**AND IN THE MATTER OF** an application by wpd Sumac Ridge Incorporated for an Order or Orders pursuant to section 41(9) of the *Electricity Act, 1998*, S.O. 1998, c. 15, Schedule A establishing a location for the Applicant's distribution facilities on public road allowances owned by the Municipality of Kawartha Lakes, Ontario, as set out in this application.

**SUPPLEMENTAL INTEROGATORIES OF THE INTERVENOR, E. SALMON**

**The Colour Map –Plan View of a 44Kv Collector Line – Dated November 13, 2014**

**The Black and White Cross Section Drawing for 44 Kv Collector Distribution Line Dated November 20, 2014**

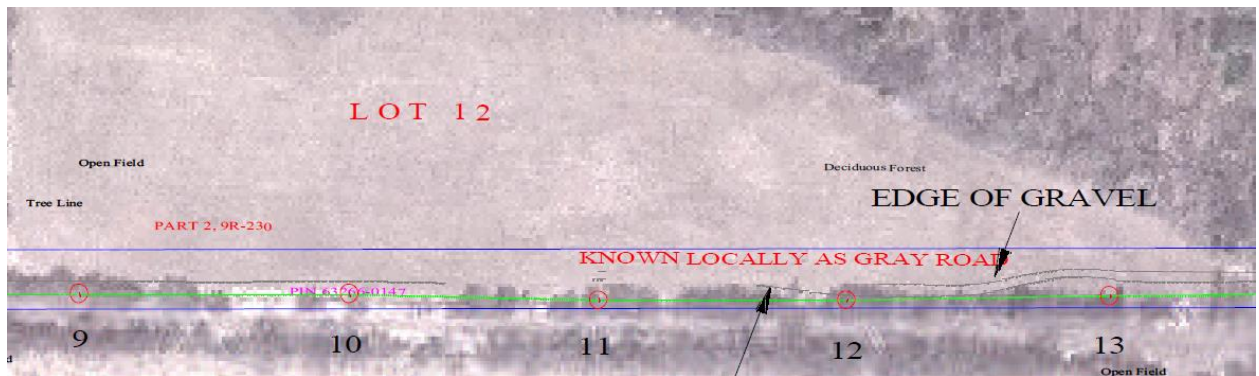
7. The unopened road allowance Gray Road is identifiable in the aerial view by the dark shapes of the hedgerows and woodlands that run along its length on the north and south side.
8. In one section of the road allowance in the colour map provided by the Applicant, the unopened road allowance is shown to be located on private property marked as Lot 12 with the 'edge of gravel' marked where there is a private trail on private lands. The road allowance Gray Road is located south of the blue lines. It can be seen as the light area

between the two dark shapes that define the hedgerows on either side of the Gray Road allowance.
